# TECHNICAL EVALUATION REPORT

## MASONRY WALL DESIGN

BALTIMORE GAS AND ELECTRIC COMPANY

CALVERT CLIFFS NUCLEAR POWER PLANT UNITS 1 AND 2

Figure 1. Response Spectrum Modification

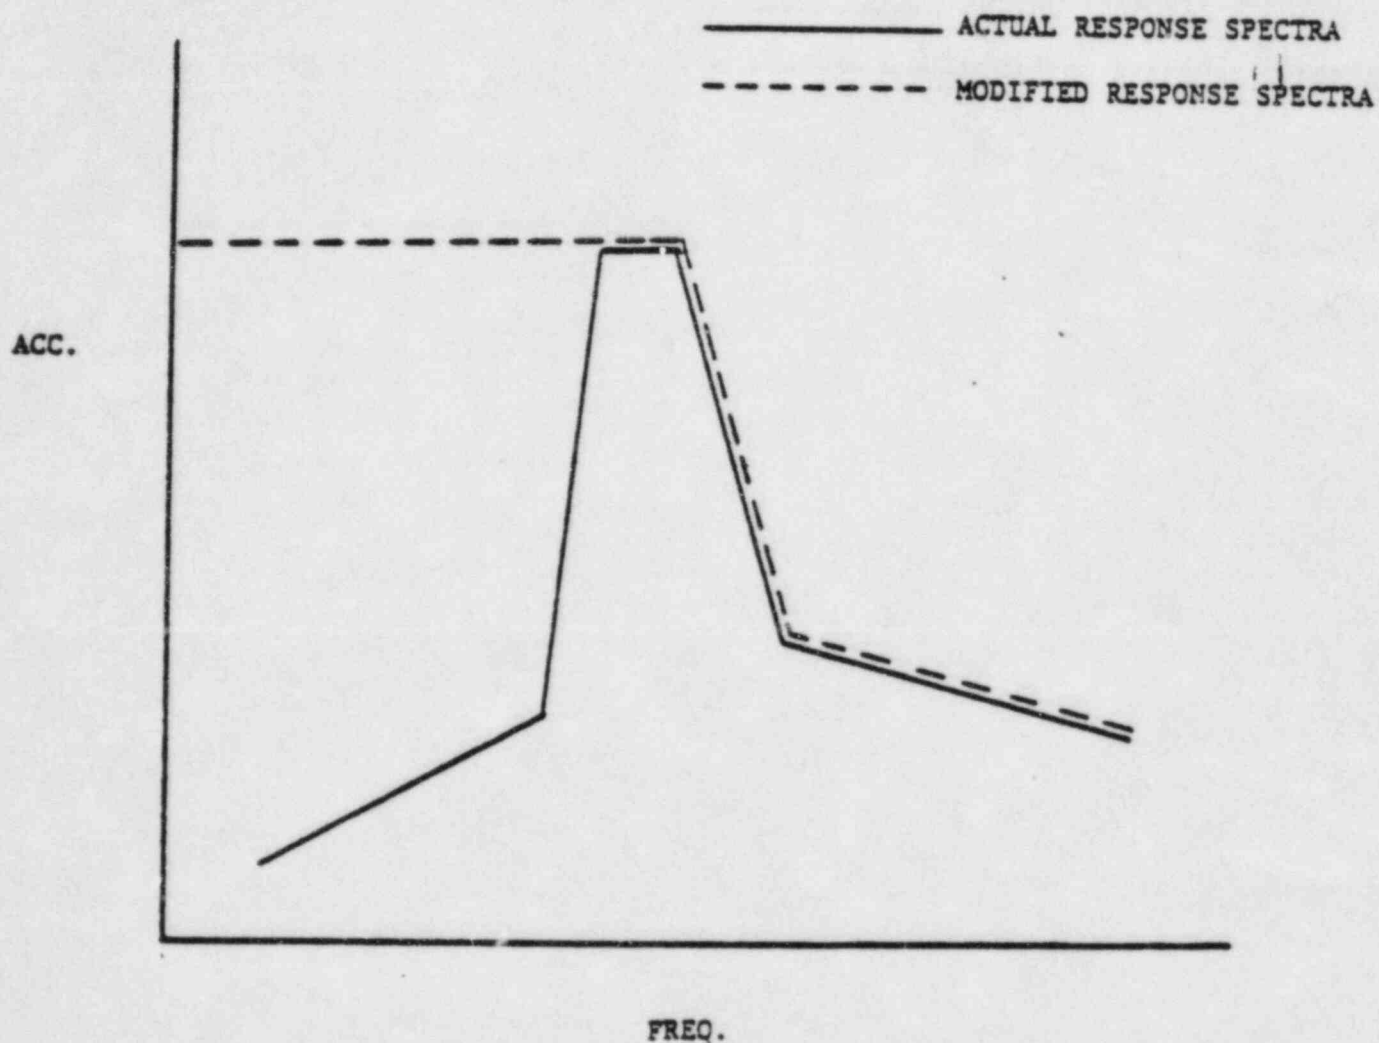
With respect to Section 5.2.1, Attachment D, Reference 2, the Licensee uses an increase factor of 1.67 for allowable masonry stresses in tension and shear, whereas the SEB Criteria allow only 1.3 for shear and tension normal to the bed joint and only 1.5 for tension parallel on the bed joint. The Licensee justifies the factor of 1.67 by claiming that it

provides a factor of safety of  $1.8 = (3 \text{ divided by } 1.67)$ . Substantiate this justification by any existing test data. The applicability of the tests should be discussed for the following areas:

- o Nature of loads
- o Boundary conditions
- o Sizes of test walls
- o Type of masonry construction (block type, mortar type, grouted, or ungrouted).

In addition, the Licensee is requested to indicate if the SEB Criteria were used, how many walls cannot be qualified, and to identify these walls.

In this response, the Licensee stated that, because all elastically qualified walls were analyzed as vertically spanning beam strips, the factor of 1.67 was used only for tension perpendicular to the bed joint. A list of eight walls was provided which would not qualify if the SEB criteria were to be used for tension normal to the bed joint. Also, the Licensee showed that actual shear stress values would fall within allowable limits even if the SEB factor of 1.3 were used instead of 1.6.

A table was provided listing the actual increase factors required to bring the walls within allowable limits and the percentage by which these factors exceeded the SGEB factor. The highest percentage of exceedance was 26% and the lowest was 11.5%. However, this increase could be compensated for by various conservative measures such as the conservative analytical assumptions of one-way vertical spans and a 2% damping value for these uncracked walls, in which masonry tension normal to the bed joint is used. In addition, whenever the natural frequency of the wall falls in the lower side of the peak response spectra, this peak value was used to obtain a conservative seismic loading as shown in Figure 1.
